Ducted Systems Technical Services Service Tips Letter

Letter: **ST-004-2020**

Subject: **Furnace Door Panel and Quarter Turn Knob Engagement**

Product: **Residential 33" A & B cabinets, condensing and non-condensing furnaces**

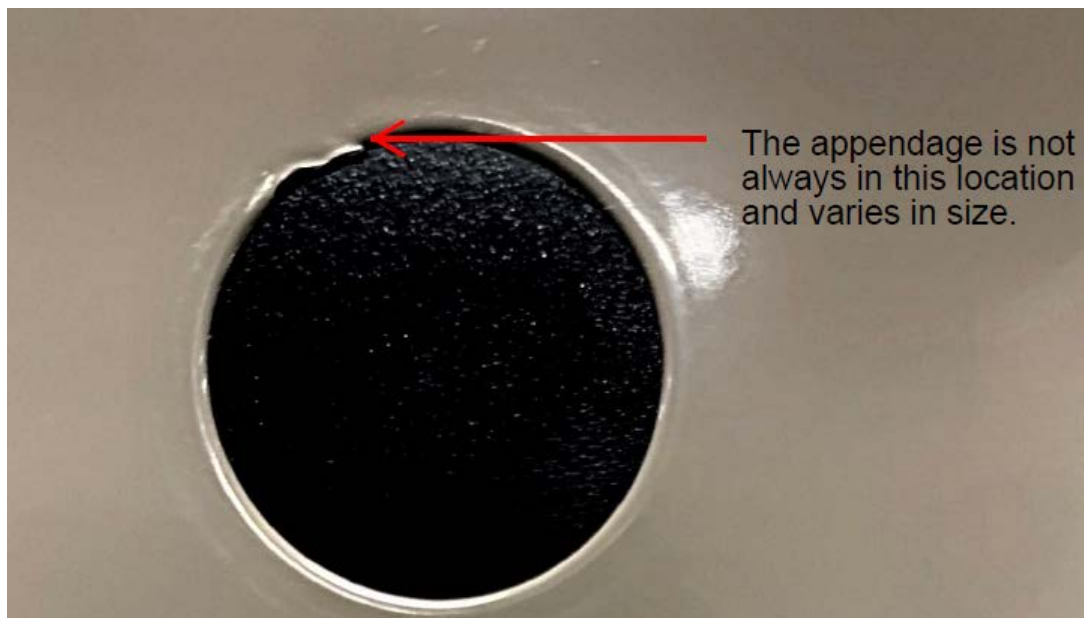
We have received some reports on the residential gas furnace used during July 2019 to Mid-October 2019 production, where the Upper and Bottom panel doorknobs are breaking or found being very loose. The reports indicated small amounts of issues with not being able to lock the knobs in place to seal the furnace's top or bottom compartments.

Through our investigation, we discovered that the reason for doorknobs being found broken or loose is because the "Hole Punch Die" tooling became dull, causing the hole to have a burr on the door panel. Due to the burr, it would cause the doorknob to break. All furnaces produced after December of 2019 are fixed. This is shown below.

If you encounter one of the subject furnaces with this issue, please replace the knob after deburring the opening using a metal file. Removal of the burr ensures a reliable installation of the new knob. The replacement knob, part number is **S1-02924485000** and can be obtained under the standard warranty process with 1 hour of labor claim. Technical support cannot issue a new door panel, due to the multiple labels associated with each door panel. The new doorknob will be installed as shown below.
